**Final Status Survey Report**  
**Appendix 2**  
**BTM-02, Final Status Survey Plan Improvements**

**Beltsville Agricultural Research Center (BARC)**  
**Low Level Radioactive Burial site (LLRBS)**  
**Beltsville, Maryland**

# **BARC Technical Memo Final Status Survey Plan Improvements**

**BTM-02**

**Figure BTM-02-1**  
**Excavation Bottom FSS Design Method**

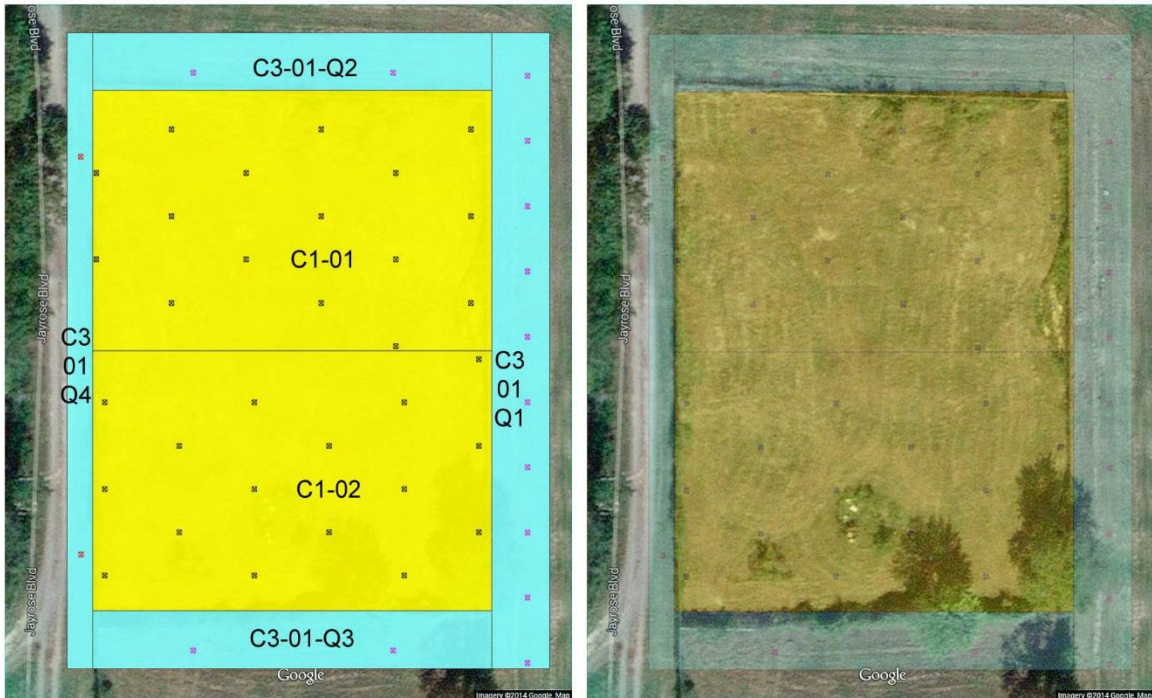
Therefore the project recommends that the excavation depth requirement specified in Section 3.11 of the FSSP (detailed in Section 3.4.3.3 above) be modified in the following manner:

*Once all interstitial soils have been excavated and transported to the laydown area, the excavated areas within the North Field area will represent a single, large excavation. ~~Any material remaining of the upper 15 feet of material below original surface grade (consisting of clean fill, waste, contaminated soil, and interstitial soil present within each disposal pit) will be excavated and removed.~~ The excavation bottom will be contoured as necessary to provide a relatively smooth surface suitable for the performance of planned survey and sampling activities.*

The excavation area will be divided into three survey units, similar to those shown in Figure BTM-02-1, Excavation Bottom FSS Design Method. The portion of the excavation bottom which was previously occupied by the burial site will be divided into two Class 1 survey units, each having an area of approximately 1,455 m<sup>2</sup>. The portion of the excavation bottom surrounding the Class 1 survey units will comprise one Class 3 survey unit with an area of approximately 1,395 m<sup>2</sup>.

Figure BTM-02-1 survey units and sample locations are presented to convey an understanding of the survey design with respect to the survey unit layout and the sample distribution pattern with associated grid spacing. The actual survey units and sample locations, while quite similar to those illustrated, will be marginally different since they will be generated using the final GPS coordinates of the entire excavation, which will not be acquired until excavation activities are complete.
